TITLE: USE PERMIT NO. 154, WILDERNESS HILLS, requested by J. Michael Rierden on behalf of Gerald Maddox, on property generally located southeast of the intersection of South 27th Street and Yankee Hill Road.

LINCOLN CITY/LANCASTER COUNTY PLANNING STAFF REPORT

****As Revised and Recommended by Planning Commission: 11/12/03****

and Design Criteria

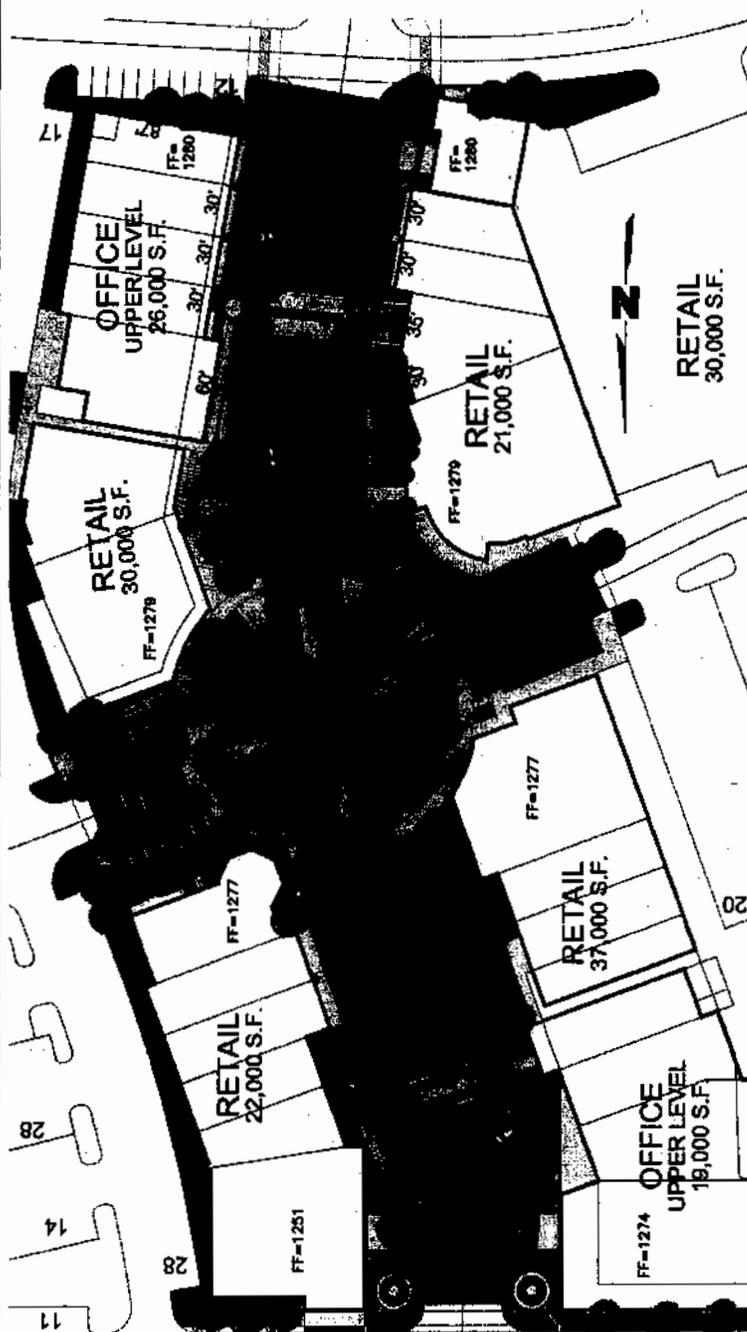
- 1.1.9 Simplify Note #2 on Sheet 16 of 17 to state "Two Facing Town Center buildings shall be constructed prior to or concurrently with the first 'big box' (floor area greater than 20,000 square feet) retail building."

- 1.1.10 Correct the title of the notes on Sheet 16 of 17 to "Town Center" not "Township Center." Delete "Big Box" from the subtitle "Big Box Design Criteria".

- 1.1.11 From the Storefront Design on Sheet 16 of 17 delete "imaginative forms".
- 1.1.12 Amend the statement on Sheet 16 of 17 to state "Other acceptable exterior material - subject to Landlord and Planning Director design review and approval."

- 1.1.14 Clarify the notes for the town center on Sheet 16 of 17 to the satisfaction of the Planning Department.
- 1.1.15 The design criteria on Sheet 16 of 17 shall apply to all buildings in the Town Center ~~in the B-2 district~~. **(**Per Planning Commission, at the request of the applicant and agreed upon by staff, 11/12/03**)**

- 1.1.16 Add a new Note #3 to Town Center Notes on Sheet 16 of 17 “All buildings within the use permit shall be subject to the design criteria. Each building’s elevations shall be first submitted to the Landlord’s Coordinating Architect for review and approval. Then a letter of approval from the Landlord’s Coordinating Architect (which shall describe how the elevations conform to the design criteria) along with the building elevations shall be submitted to the Planning Director for review and approval, prior to issuance of a building permit.”

7. All notes located on Sheet 16 of 17 have been revised accordingly as requested by comment #7.
8. The note "Design criteria for the other buildings in the Community Center, other than the Town Center, will be developed by the applicant with written approval of the Planning Director prior to issuance of building permits for the buildings in the Community Center other than the Town Center" has been added as requested by comment #8.
